Public Meeting  
 ALTERNATIVE SOURCE TERM REGULATORY GUIDANCE (DG-1081; SRP15.0.1)  
 February 15, 2000

# Comments on DG-1081 Gap Fission Product Content

Specific DG-1081 "Gap Fraction" Revisions  
DRAFT – 2/15/2000

## Composite Data From Both Reports With Bounding Envelope

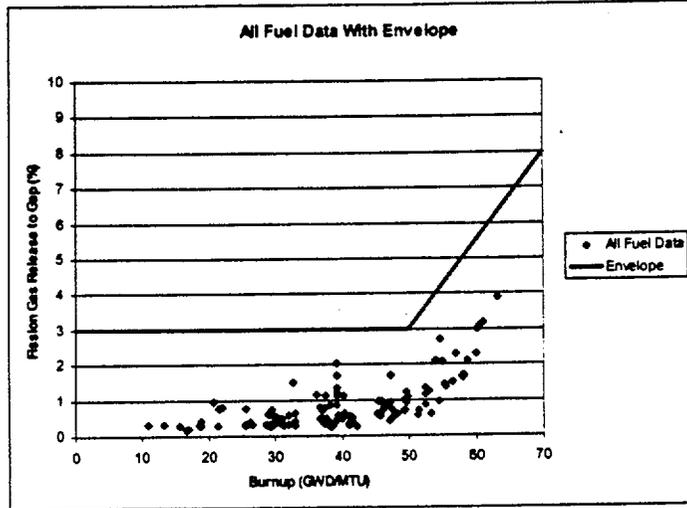
- NRC position is based on FRAPCON-3 analysis; however,
  - details of the FRAPCON-3 analysis input assumptions are not available to the public
  - results appear to be excessively conservative relative to measurements from actual fuel rods
- Industry proposes a model (very conservative) that is based on actual measurements for a number of fuel designs over a wide range of burnup

- The ANS 5.4 model, used traditionally, is overly conservative due to its exponential burnup-dependent multiplier, based on:
  - few data points
  - plutonium/uranium mixed oxide fuel
- The NRC FRAPCON-3 model and analysis have not provided to industry
- High-burnup gap content measurements from actual fuel rods are available
- Fuel rod behavior for the control rod ejection event is being addressed in NRC's high-burnup fuel research and evaluation program

Rod Average Burnup (MWD/MTU)	Industry Proposed Gap Fraction for Use in Design Basis Analysis - No Heatup (%)
0	3
20,000	3
30,000	3
40,000	3
50,000	3
60,000	5.5
62,000	6.0
70,000	8.0
75,000	9.25

## Example of Bounding Envelope of Fuel Rod Power Vs. Burnup

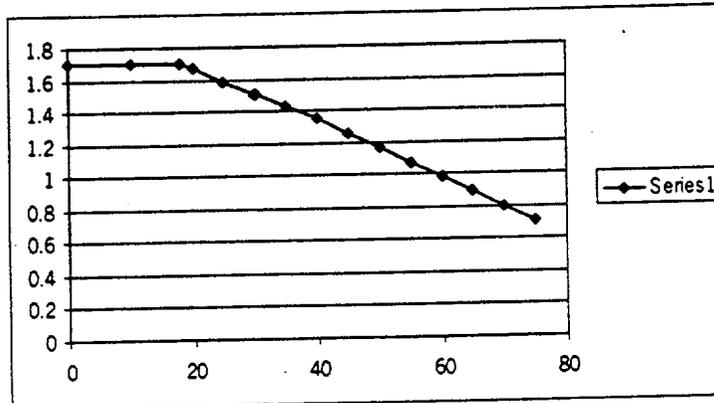
- Fission product content in fuel-cladding gap =  
(total fuel rod content) x (percent released from pellet)
- Total fuel rod content = (core average fuel rod content) x (radial power peaking factor)
- NRC proposes using the maximum power peaking factor for all burnup levels
  - industry believes this is excessively conservative
- Industry proposes using a power peaking factor that bounds actual analytical results

- For low-burnup fuel (<30,000 MWD/MTU), use the radial power peaking factor from the Core Operating Limits Report (COLR) Power Peaking Factor for Core Inventory Calculations
- For fuel with higher burnups, use a radial power peaking factor based on the bounding power history envelope associated with the fuel cycle design being used
- if a radial power peaking factor from a power history envelope is not available, use the low-burnup value from the COLR
